Technical change to FieldPower® IP65 power supplies

Please pass on this Product Change Notification (PCN) to your employees and, if applicable, to your customers.

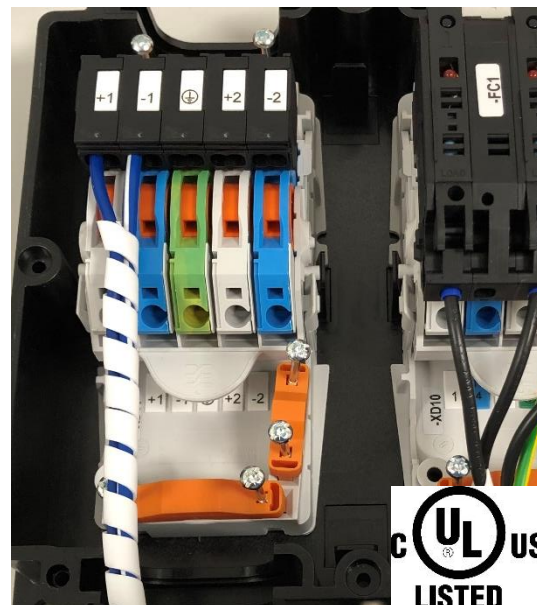
In the course of the changes for the new UL approval and the extension of the product range by a 48VDC power supply, the wire bridges between "+1" and "+2" or "-1" and "-2" on the secondary side connector are removed, see pictures. In future, the 24V potential is to be tapped via the connections "+1" and "-1". If required, the wire bridges can be prepared and assembled by the customer.
